Title: **STAGE 1 QUALITY/SAFETY AUDIT**

Proposed Residential Development at Waterfall Road, Cork

Report reference: **0952R01 Rev 2**

Drawing NRB-TA-001-02

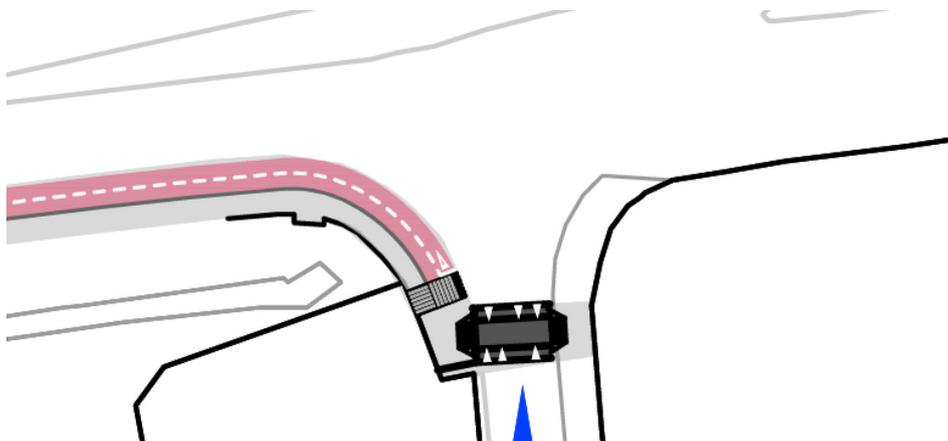
It is proposed to provide a pelican crossing at the north eastern tie in of Waterfall Road. It is understood that the exact location is to be agreed with CCC. There is a risk that the location of the signals may be too close to a private access or that there may not be enough footpath space for waiting pedestrians if it is located where there is a pinch-point. This could lead to passing pedestrians entering the carriageway where they could be struck by passing vehicles.

It is recommended that the pelican crossing include buildouts into the existing relatively wide carriageway so that there is extra refuge area for pedestrians waiting to cross, there is a shorter crossing distance and that the signals also act as a traffic calming feature. Crossing specific public lighting will be required.

3.1 - Pelican Crossing	Yes	Yes	<i>NRB Comment</i> – the location & outline design was agreed in Principle with Cork County Council (CCC).	Yes
3.2 – Raised Platform At Audi	Yes	Yes	<i>NRB Comment</i> – A ramp warning sign has been incorporated and the crossing is to be as far back as possible (to match the existing crossing).	Yes

Drawing NRB-TA-001-02

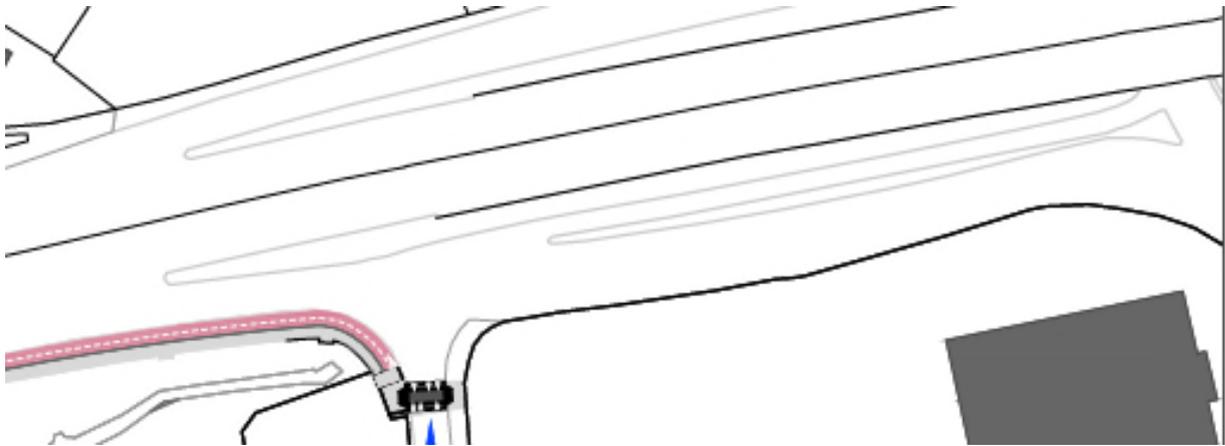
It is proposed to provide a raised uncontrolled crossing at the entrance to the Audi Garage/Heiton Buckley. There is an existing uncontrolled crossing at a similar location. There is a risk that if the crossing is brought closer to the junction with the N40 ramp that vehicles turning at relatively high speed may not be able to stop before the crossing point.

It is recommended that the crossing be suitably set back from the junction mouth.

Drawing NRB-TA-001-02

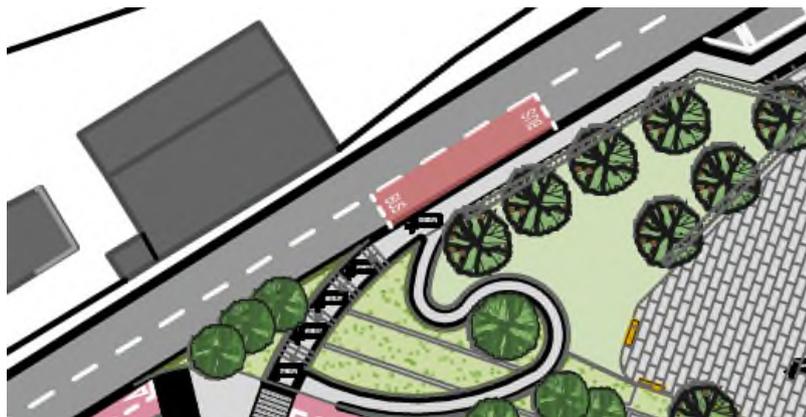
The existing cycle track along the N40 ramp from the N71 roundabout is only one-way and is also available to pedestrians. This could lead to conflict between cyclists that will be travelling contra flow when the new facility is opened.

It is recommended that the existing one way cycle track be made a shared use facility in both directions from the access to the Audi Garage/Heiton Buckley to the Dunnes Stores pedestrian crossing on the N71.

3.3 – Existing Cycle Facility on the N40 Ramp	Yes	Yes	<i>NRB Comment</i> – the existing concrete apron area to the southern boundary of the ‘ramp’ (identified in the RS Audit Report) is a shared surface, used by cyclists and pedestrians, and has operated as same for many years without any issues arising we understand. It is currently very infrequently used. There is an historic push button controlled crossing provided immediately at the Audi Garage, which, when in operation, previously allowed the safe crossing of dismounted cyclists. Notwithstanding the crossing status, at some point, eastbound cyclists must currently eventually dismount to cross at the busy N40 Bandon Road roundabout.	Yes
